IGP TAP Transmission Subgroup

Feedback on REZ Study

10/xx/2021

This feedback to HECO is based on HECO's slides and presentation on their initial REZ Study on 10/1/2021.

O`ahu REZ Study - REZ Dispatches

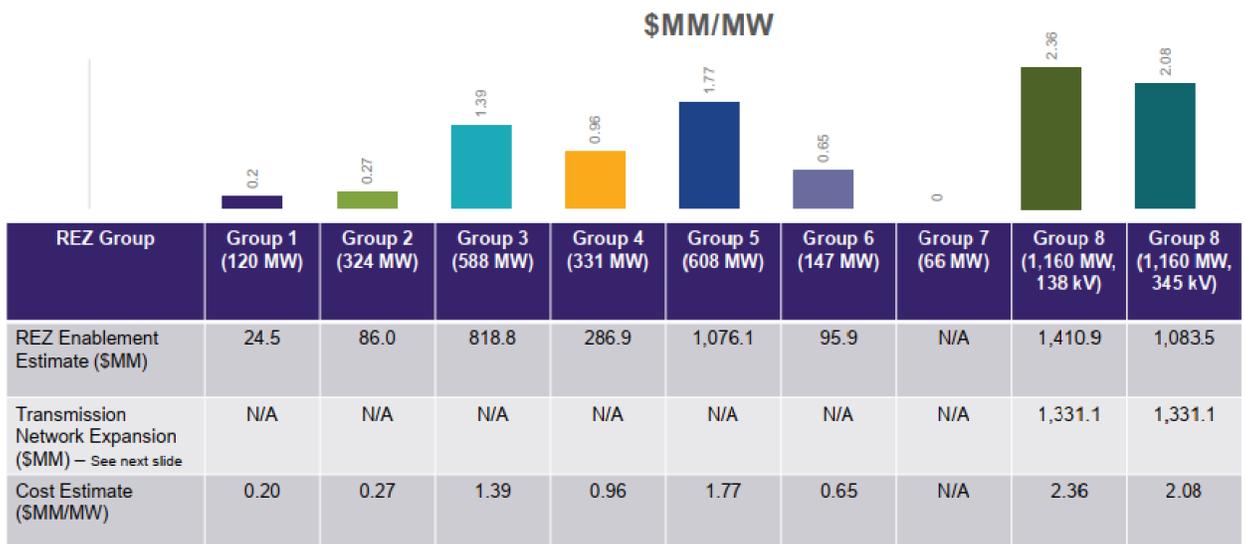
How were the dispatches chosen? (For example, the dispatches in the screenshot below)

- Response: We chose a range of dispatches designed to push each REZ zone to peak output.
- TAP follow up: The dispatches chosen are very important to the study outcome. Dispatches that draw from multiple REZ zones in parallel may produce a lower need for transmission.

- Response: Agreed. See the study outcomes. For Oahu, network upgrades are only needed for one REZ group (Group 8), and only beyond 300 MW. Beyond that threshold, Group 8 appears likely to be unfeasible. **We will add a note about the 300 MW threshold to the slides.** This REZ group is one of the most likely to see stakeholder pushback due to its location.

O`ahu REZ Study – Cost Estimate

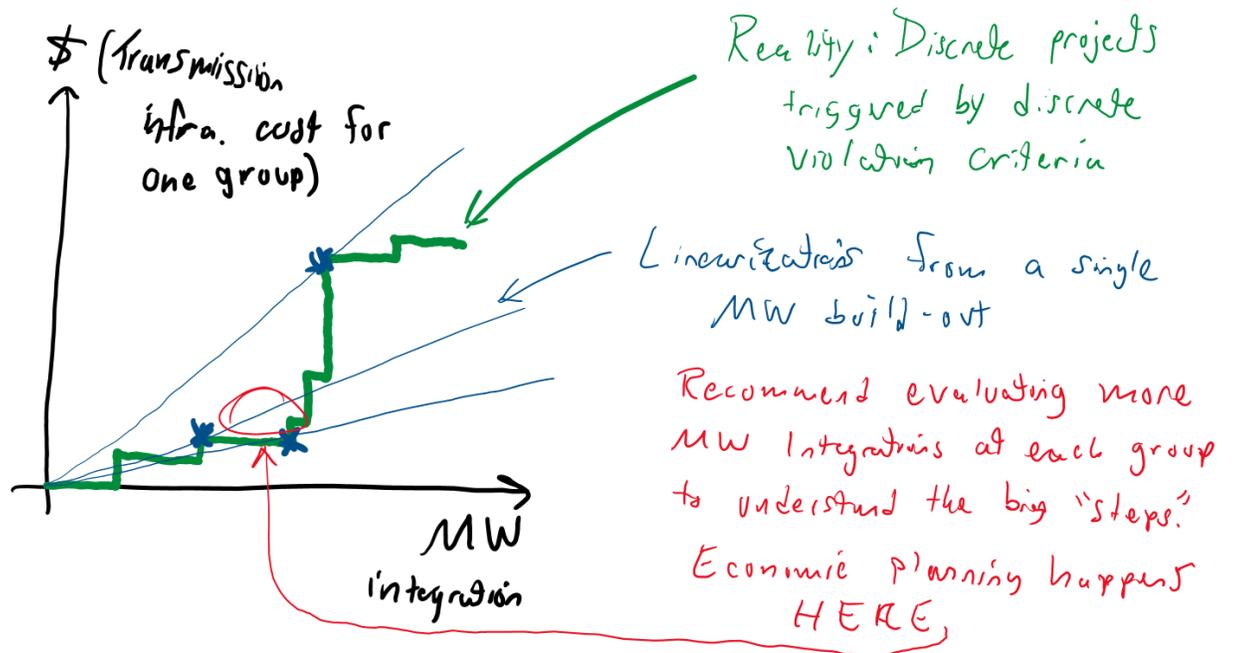
- TAP follow up: The approach of ranking groups is a good one. However, the per-unitized cost estimate (screenshot below) misses the very important fact that the cost of transmission infrastructure does not vary linearly with the MW of REN integration; it varies in discrete steps (see hand sketch below). Linearizing it can result in a misleading metric that then feeds into the beginning of the RESOLVE-PLEXOS process shown on slide 57 and affects all downstream results. **An evaluation of more MW integration levels is strongly recommended for Group 8, and recommended for the other groups as it may determine a different priority/cost for integration in each zone; for example, a stepwise \$/MW curve for each group may be obtained, as sketched below. At the same time, the TAP recognizes that this is an initial pass at transmission cost estimation that will be refined in future steps.**
